SUBJECT: Sumter Electric Cooperative, Inc. - Major Development – Preliminary Plans for Substation Expansion – SR 44/Wildwood (Staff recommends approval).

REQUESTED ACTION: Approve Preliminary Plans for Sumter Electric Cooperative, Inc. Substation Expansion.

Sumter County Submittal Set - Preliminary and Engineering Review

Work Order
900852
Drawing #
CO- 02 - 104

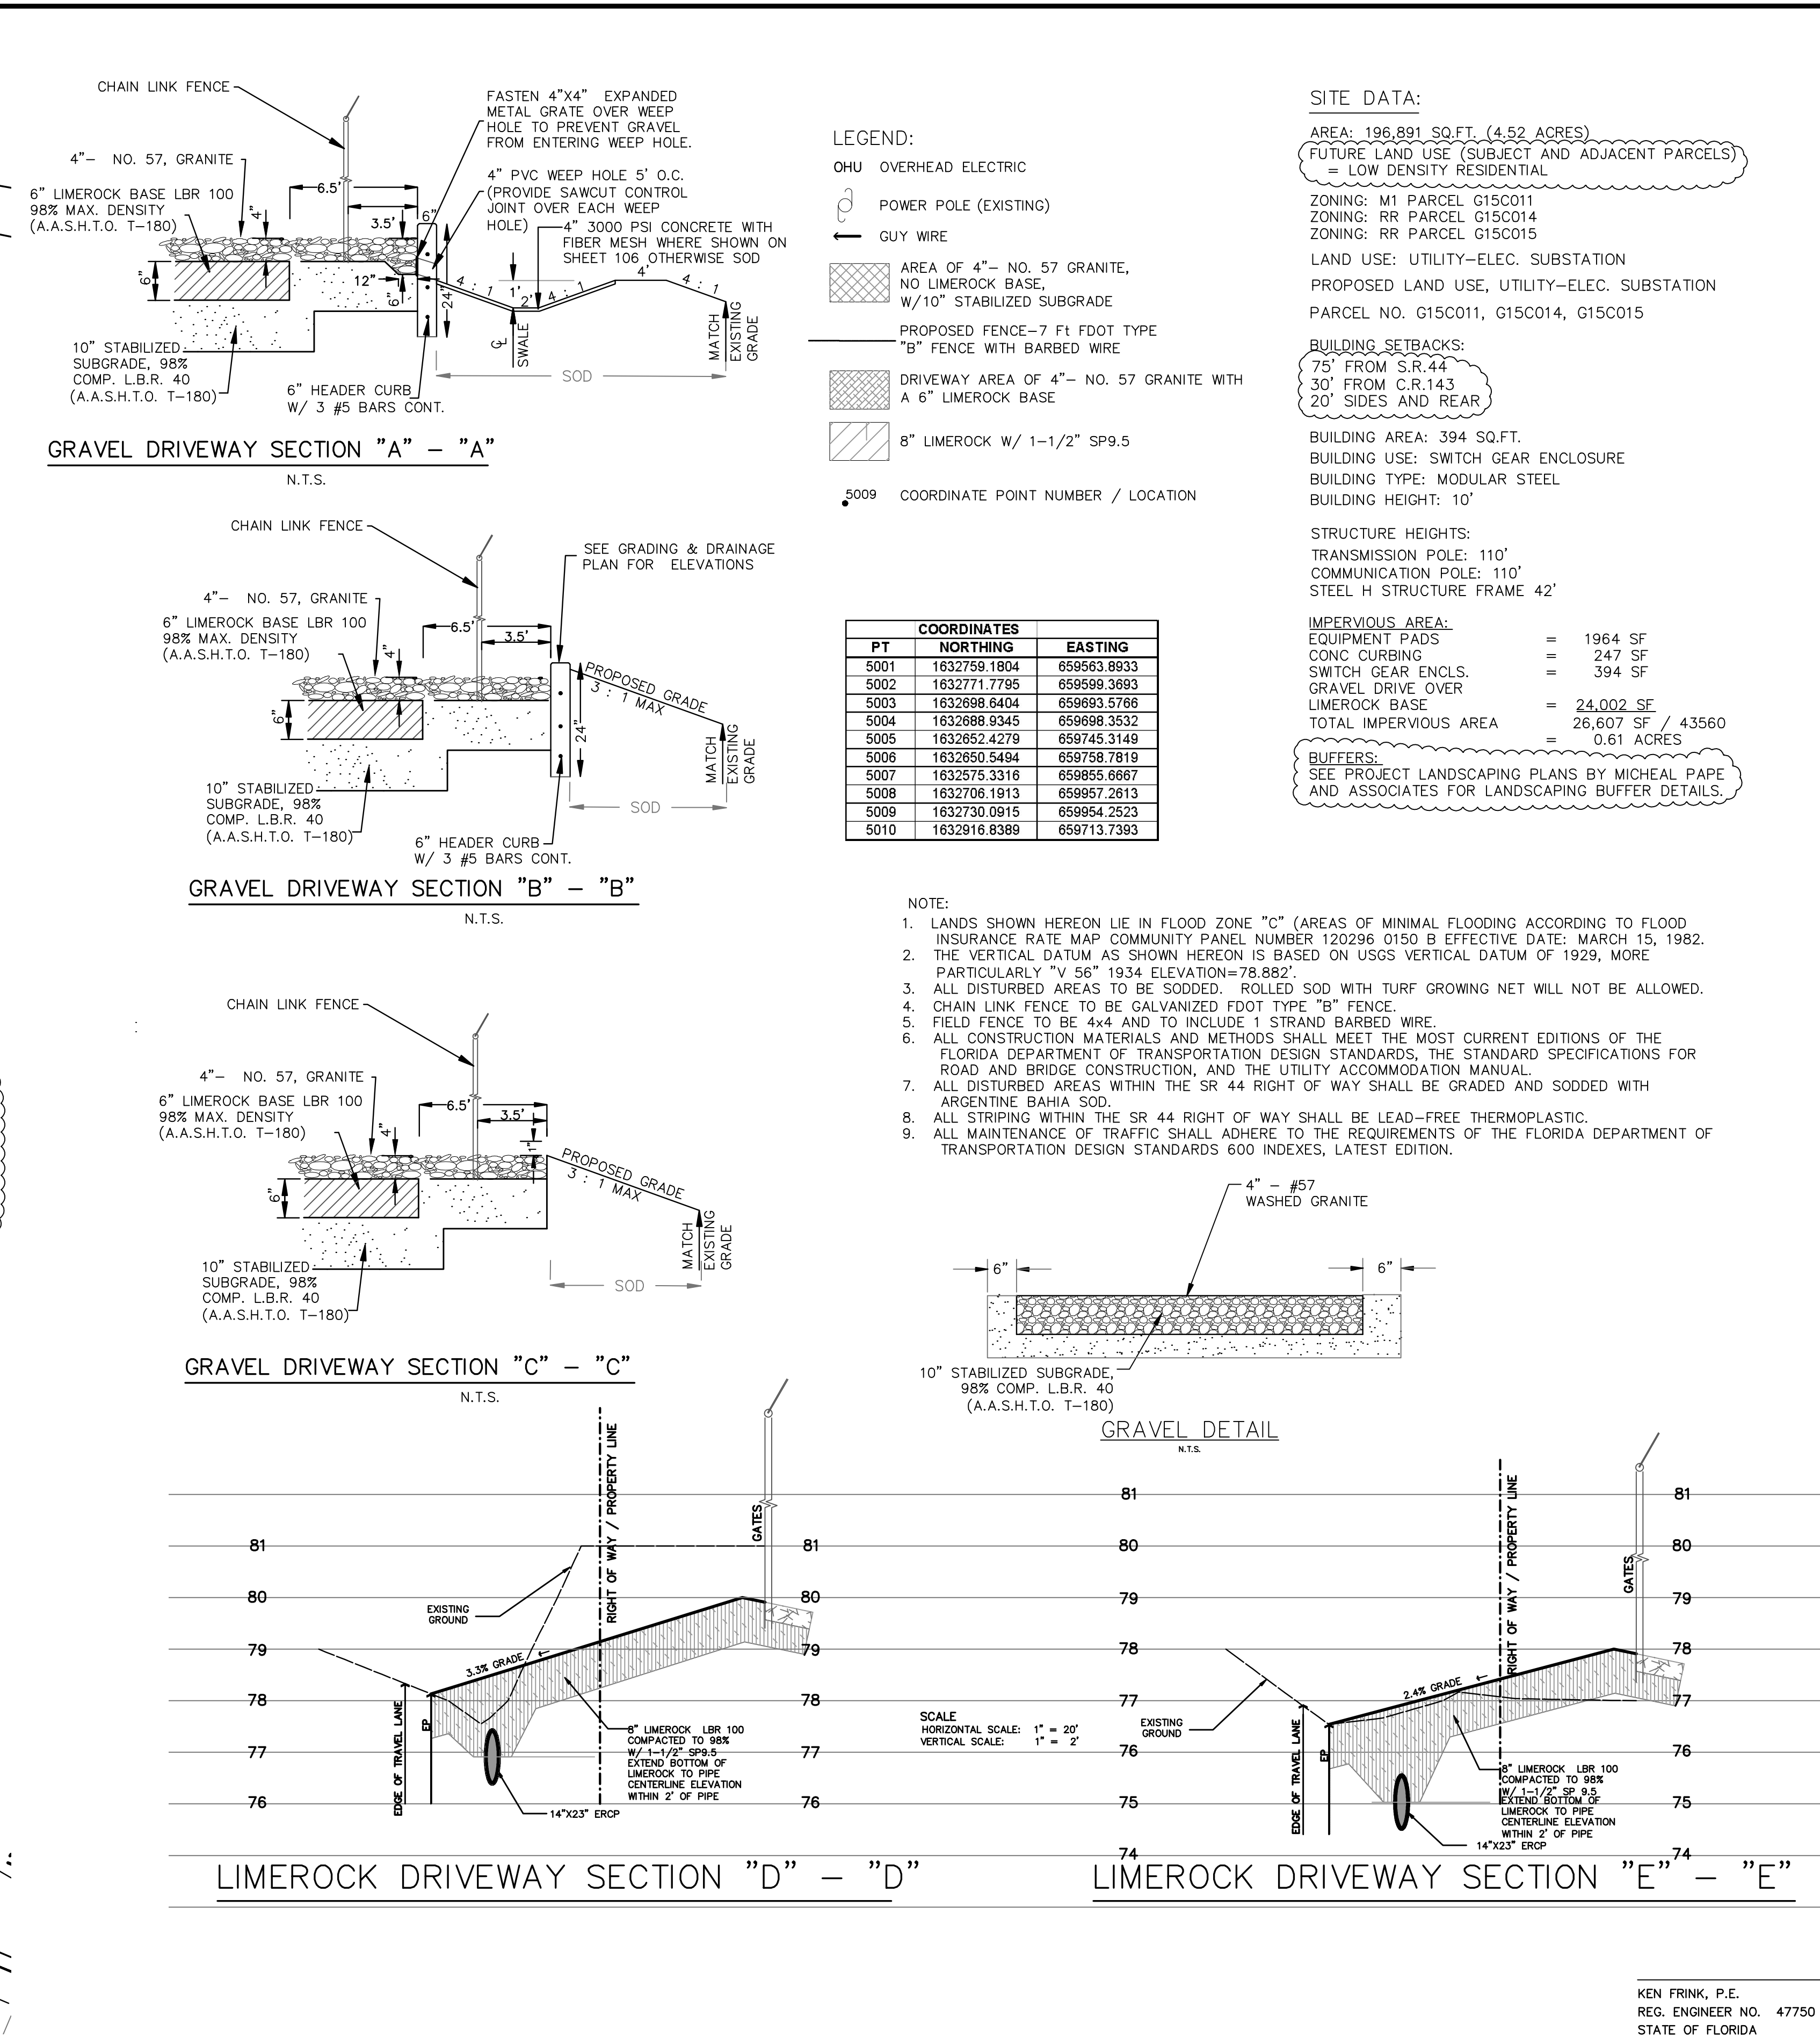
Revision:	BY:	Date:
1. REVISED PER FDEP COMMENTS	K.F.	4/28/10
2. REVISED PER COUNTY COMMENTS	K.F.	7/12/10

- 1 Please see the updated sheet 104 with the corrections made.
2. The callout on sheet 105 to remove the western drives, now includes the eastern drive and pipe.
3. A submittal has already been made to Public Works for the access to CR 143 and should have already been issued. As of now, we have not received a copy.

Work Order
900852
Drawing #
CO- 02 - 106

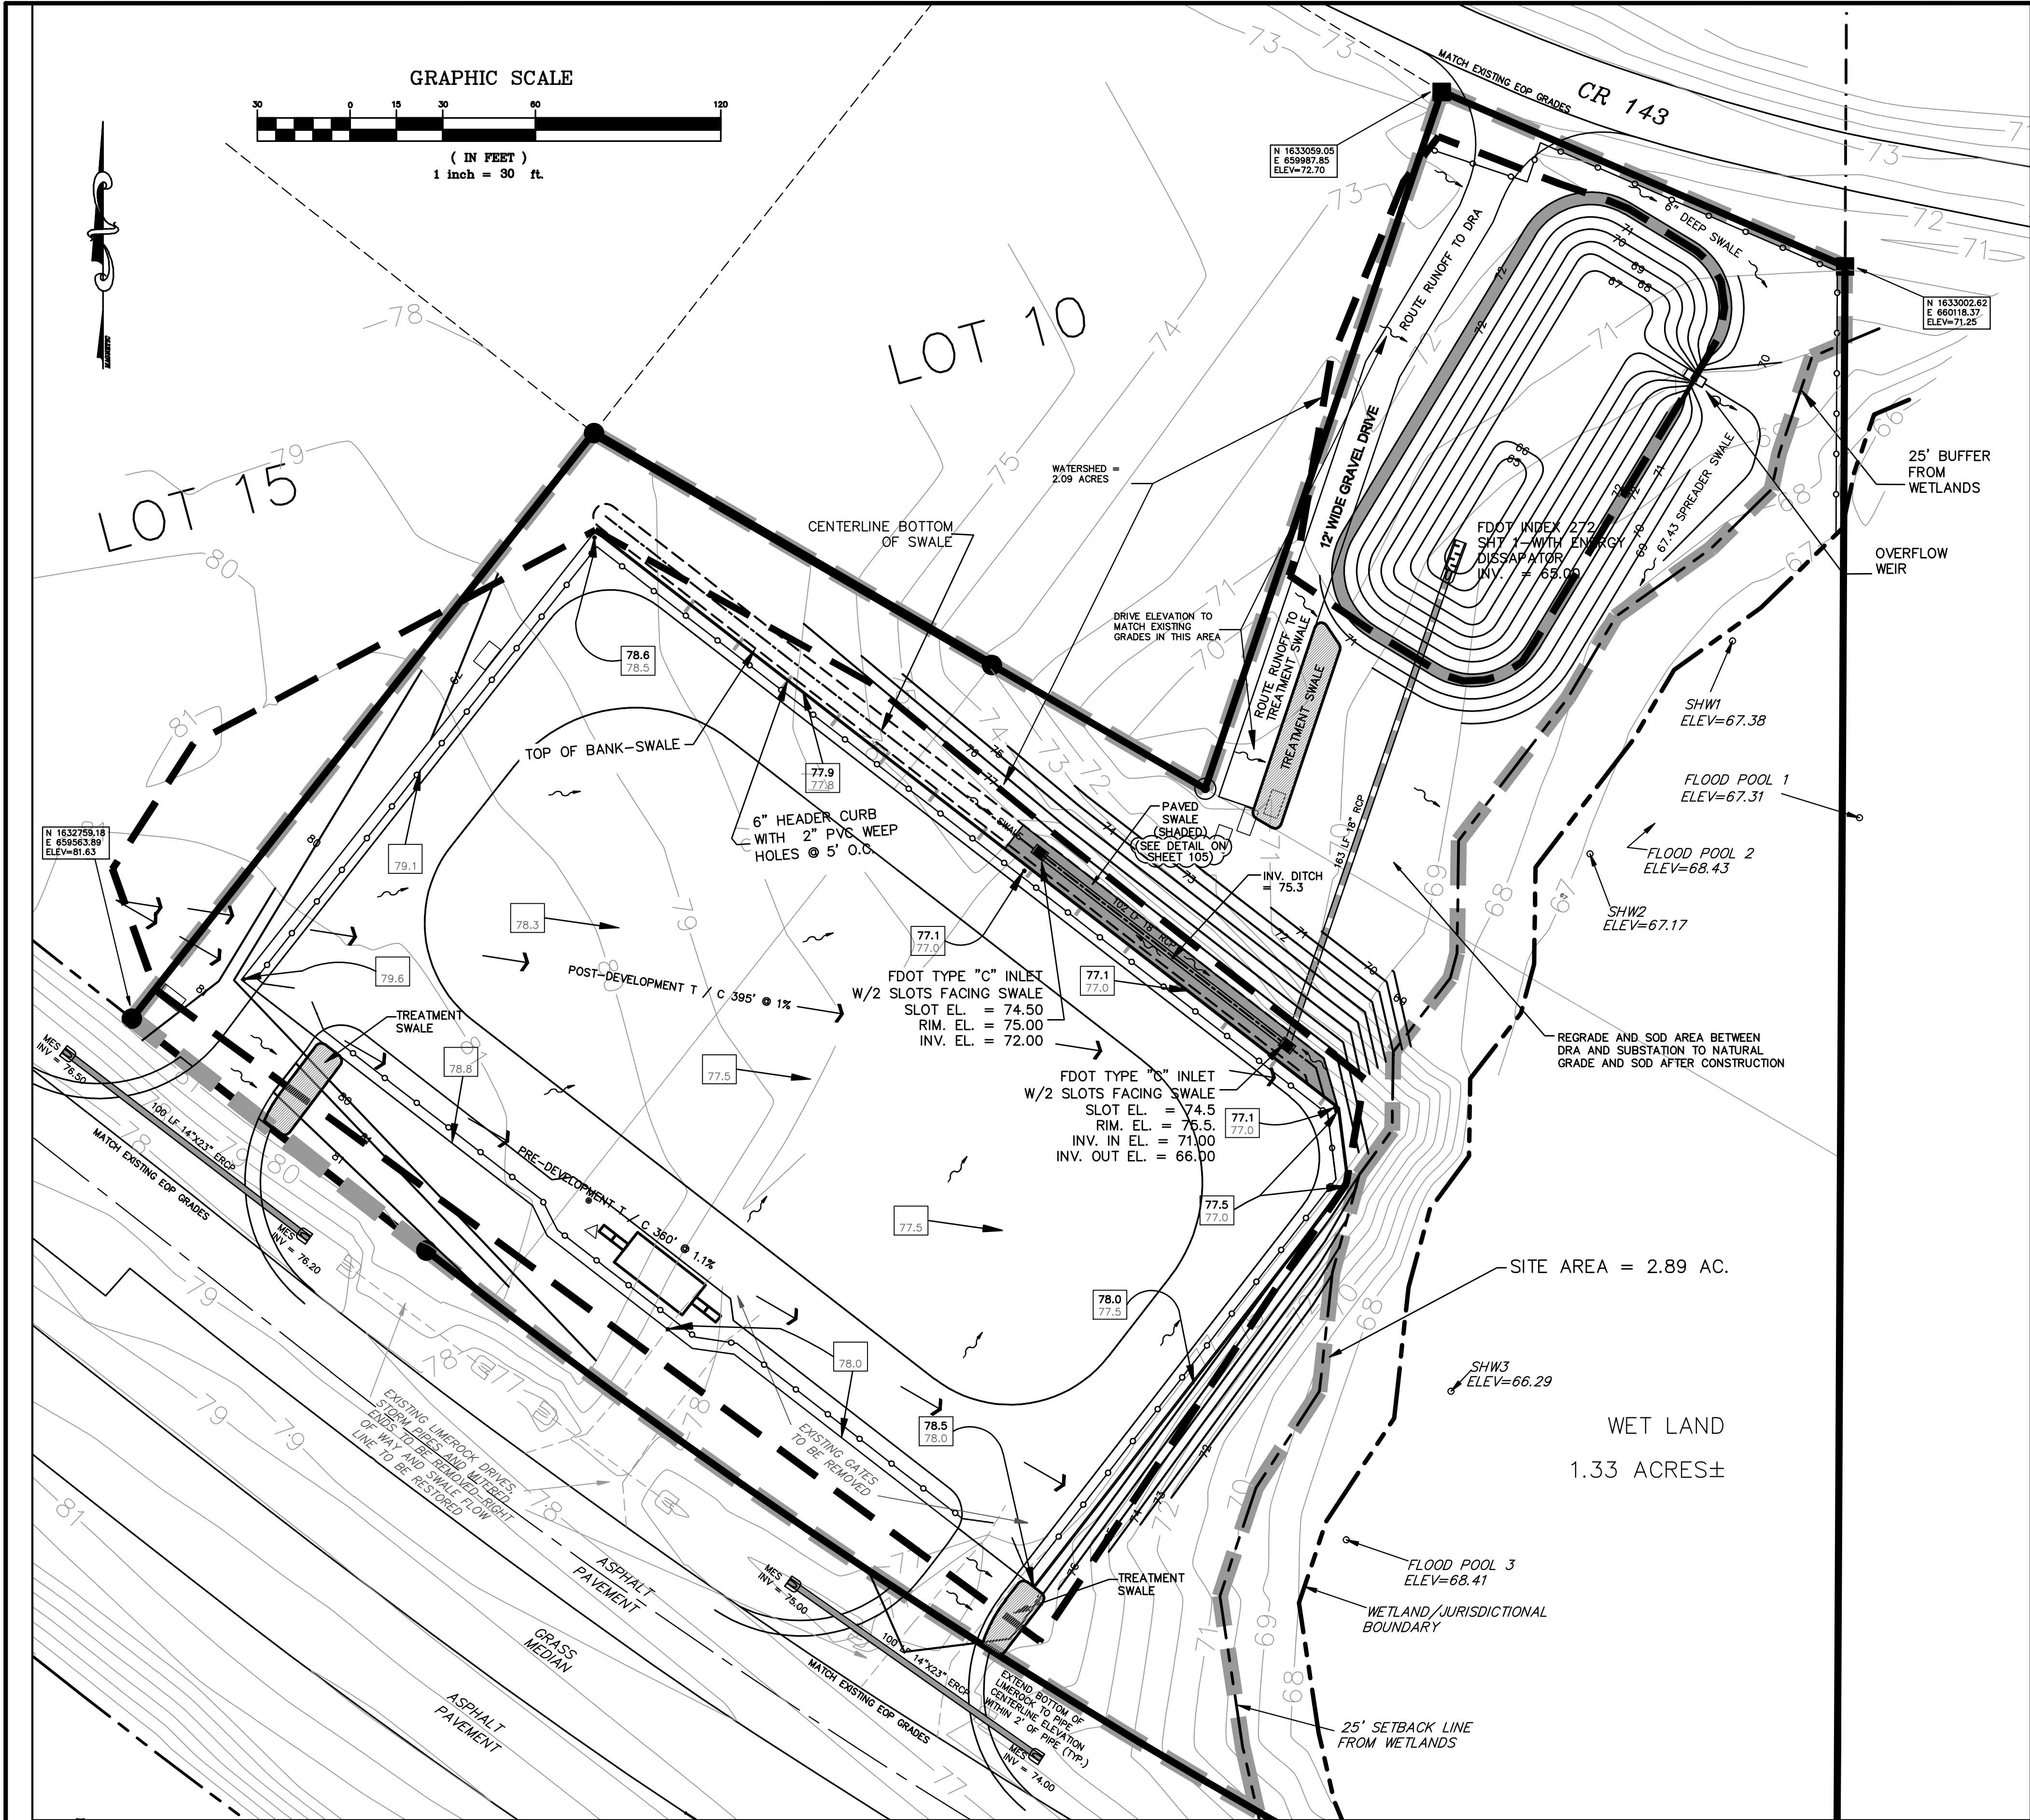
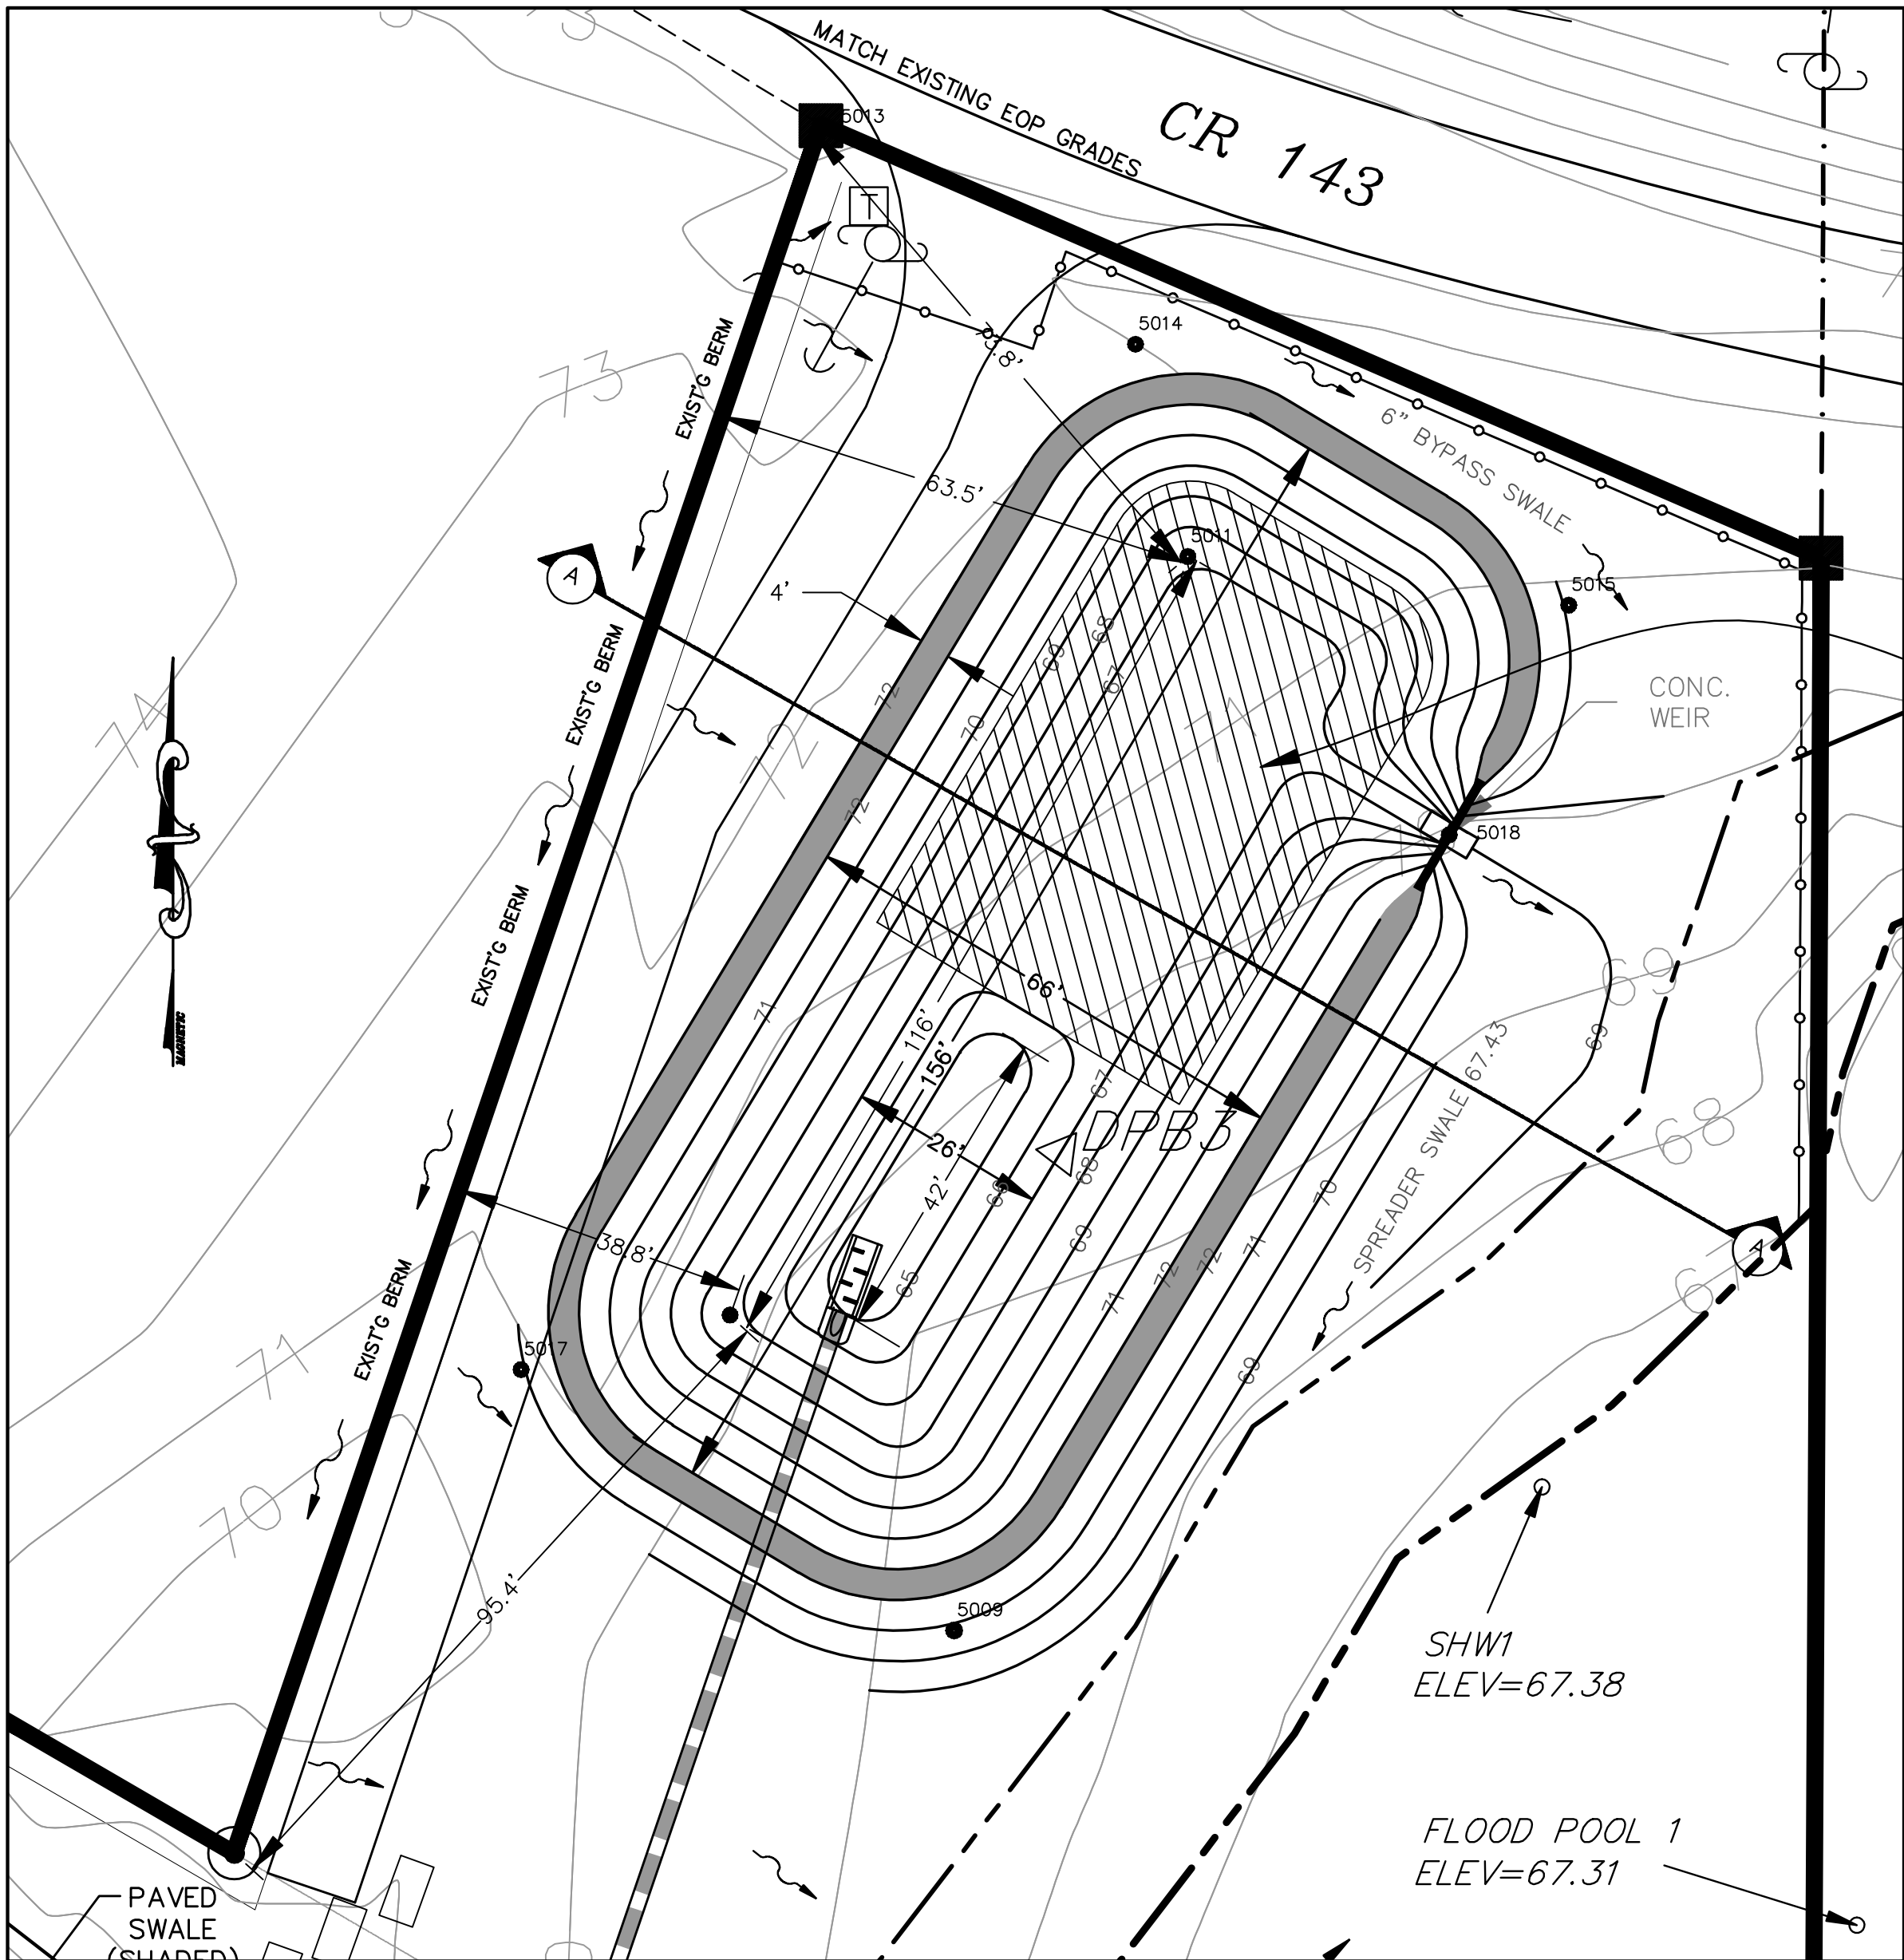
Revision:	BY:	Date:
1. REVISED PER FDEP COMMENTS	K.F.	4/28/10
2. REVISED PER COUNTY COMMENTS	K.F.	7/12/10

5. A stop bar has been added to the CR 143 driveway as requested.
6. The driveway on to CR 143 has been revised to include 35' radius returns.
7. The requested detail can be found within section A-A on sheet 105. A note has been added to sheet 106 clarifying this.
